SUBJ: Amendment to Material License 26-00138-10 Amendment No. 14

As discussed in a telephone conversation on December 16, 1982, with Jim Meyers of your office, we would like to change the location of the J. L. Shepherd Associates Cesium-137 Mark I Irradiator from Room R-122 of our Research Building as indicated in paragraph D1 of our letter of September 8, 1982, to Room SW 208 in our main hospital building (drawing attached as Appendix I & II). All other statements in our letter will remain unchanged.

APPENDIX ONE

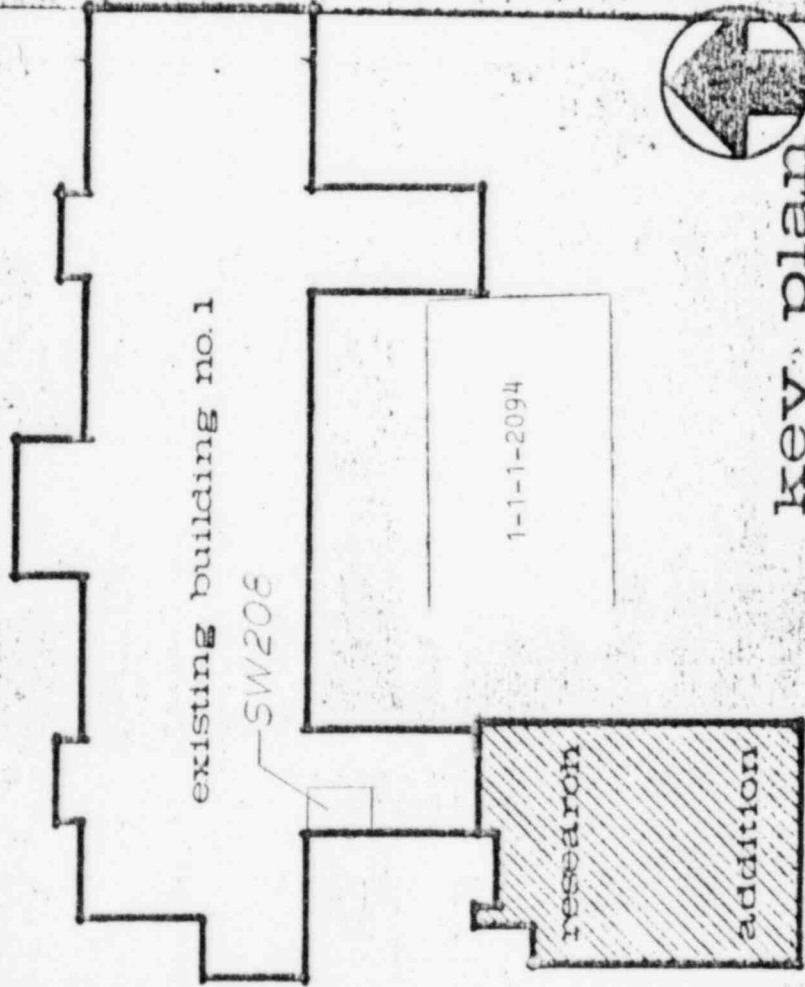
This change was brought about due to the fact that it has been decided to irradiate all blood given to IMMUNOSUPPRESSED patients, and moving the irradiator to the Laboratory Service Wing will make it more accessible to laboratory personnel during emergencies.
